APPLICATION NO.	FILING DATE	FIRST NAMED INVENTOR	ATTORNEY DOCKET NO.	CONFIRMATION NO.
10/554,624	10/27/2005	Ryouichi Koga	P28729	7272
52123 7590 02/28/2011 GREENBLUM & BERNSTEIN, P.L.C. 1950 ROLAND CLARKE PLACE RESTON, VA 20191				
EXAMINER YOUNKINS, KAREN L				
ART UNIT 3751		PAPER NUMBER		
NOTIFICATION DATE 02/28/2011		DELIVERY MODE ELECTRONIC

# Office Action Summary

## **DETAILED ACTION**

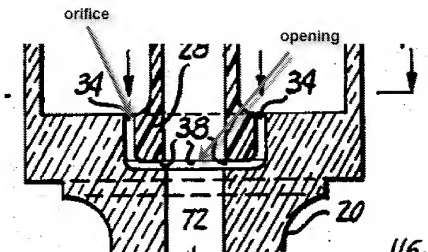
14. Regarding Claims 1 and 13, Gallo teaches a nozzle device comprising a spray hole 22, a pipe 30 forming a first flow path, a cover member (16/20) has the spray hole and surrounds the pipe. The cover member is cylindrical about 30 and is integrally formed. A front end, shown where reference character 20 points in figure 2, is closed and prevents washing water from exiting through the front end. There is a space (shown at 36) between an outer surface of the pipe and an inner peripheral surface of the cover member. This space forms a second flow path that introduces water to the

spray hole, such that the second flow path is configured to surround the outer surface of the pipe in a circumferential direction of the cover member (see figure 2).

15. Regarding Claim 2, a spray member (shown generally in the area around 34 and 28) has an orifice that is capable of merging washing water from the first and second flow paths as claimed.

16. Regarding Claim 3, the spray member has an 'internal space' with an opening at one end and an orifice at another end (see examiner annotated drawing above). The first flow path is capable of introducing water to the internal space via the opening, and the second flow path is capable of introducing water to the internal space from a peripheral surface of the spray member (see arrows in figure 2). The 'internal space' is an open area in the device. Therefore, there are infinitely many cross sectional areas of all sizes within the internal space, the internal space has a cross-sectional area that gradually or continuously decreases from opening to orifice. Similarly regarding Claim 10, there are infinitely many cross sectional areas of all sizes within the first flow path and the opening of the internal space.

17. Regarding Claims 4-5 and 7-9, (from opening to orifice) the internal space includes a first space having a first inner 'diameter' from said opening to said orifice, a second space having a second inner 'diameter' smaller than said first inner 'diameter', and a third space having a third inner 'diameter' smaller than said second inner

'diameter'. It is noted that the term 'diameter' renders the claim indefinite as discussed above and are treated as distances. The 'internal space' is an open area in the device. There are infinitely many distances of all sizes within the spray space. Liquid introduced from the second flow path is supplied to the second space, and all other spaces, as it moves through the device. The second space may have a cylindrical space (figure 2 is a cross sectional view), and the liquid introduced from the second flow path is supplied along an inner peripheral surface of the cylindrical space, and all other spaces, see flow of liquid arrows in figure 2.

18. Regarding Claim 11, the spray hole 22 is formed on a peripheral wall in the vicinity of a front end of the cover member (see figure 2) and is 'inserted' into the front end of the cover member as the 28 and 22 are not formed of the same piece, 28 insertably operates within 22/16.

21. Regarding Claim 15, the bottom end of the cover member (which is a 'peripheral wall') as shown in figure 2 is flat and in the vicinity of the front end. The spray hole is formed on this flat surface, see figure 2.

23. Regarding Claims 17-18, the connection between the protrusion at 28 (or 'second flat portion') and the corresponding side wall of 16 (around the opening at 34, or 'first flat portion') is a 'positioner' to the extent claimed, as the threads are capable of positioning a device. The orifice is 'positioned relative' to the spray hole as they are within the same device. The pipe is 'inserted' and positioned in such a way that the second flat portion and first flat portion are opposite. an See figure 2. Regarding Claim
